NORTHEAST POWER COORDINATING COUNCIL, INC.  
1040 AVE OF THE AMERICAS, NEW YORK, NY 10018 TELEPHONE (212) 840-1070 FAX (212) 302-2782

## NPCC Request for Criteria Clarification

Request for a Clarification of Criteria
Date submitted: December 1, 2017 Date revised version submitted: n/a
<b>Contact information for person requesting the clarification:</b>
Name: <a href="#">Alan Adamson</a>
Organization: <a href="#">New York State Reliability Council (NYSRC) Reliability Rules Subcommittee</a>
Telephone: <a href="#">352-989-4653</a>
E-mail: <a href="mailto:aadamson@nycap.rr.com">aadamson@nycap.rr.com</a>
<b>Identify the Directory that contains the Criteria requiring clarification:</b>
Directory Number: <a href="#">Directory 1</a>
Directory Title: <a href="#">Design and Operation of the Bulk Power System</a>

Figure 1

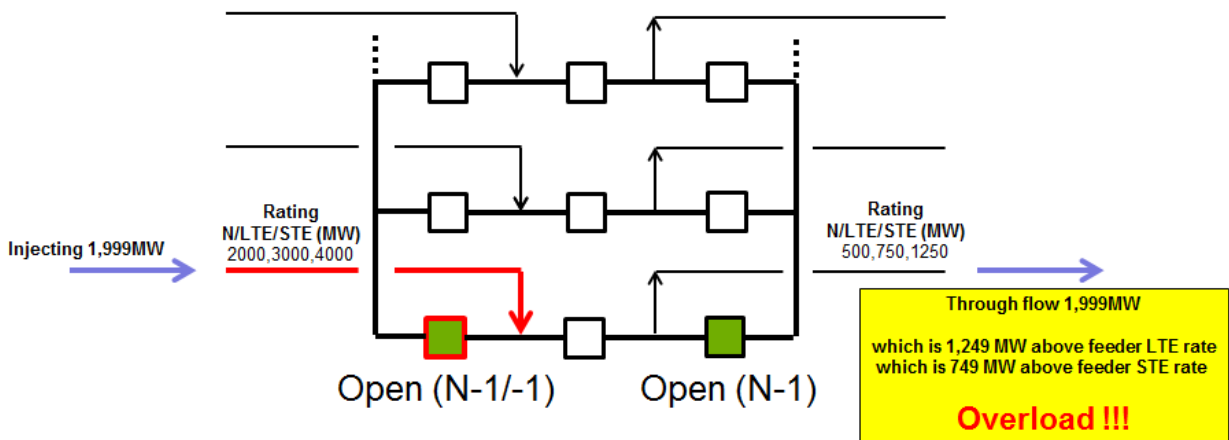
Under such N-1/-1 events, a high capacity injection (ex.: AC transmission, HVDC, or a generating unit) can be isolated onto a low rated transmission circuit (possibly loading it above its LTE or even its STE rate). Please see [Figure 1](#) below:

1. Why does NPCC Directory 1 omit N-1/-1 event such as open breaker followed by an open breaker?

A possible solution to the identified scenario above (Figure 1)\* could be to open the middle breaker as a "system adjustment" within 30 minutes before the second contingency (in effect tripping the low rated transmission circuit). This action would eliminate the postulated overload illustrated in Figure 1.

2. Does NPCC Directory 1 postulate that the opening up of a circuit breaker falls within the definition of a "system adjustment"?

Planning scenarios in Table 1 are not expected to test all operating scenarios. The planning requirements in Directory 1 are used for the design and planning of the power system, while the operations requirements are applicable to operations scenarios. In the de-scribed scenario, after the first breaker opens, available control actions for operators such as opening a breaker or even taking a line out of service would result in a configuration that is covered by planning criteria.

While not specifically mentioned in Directory 1, opening up of a circuit breaker is a system adjustment to be considered in planning timeframe, provided it can be implemented within 30 minutes.
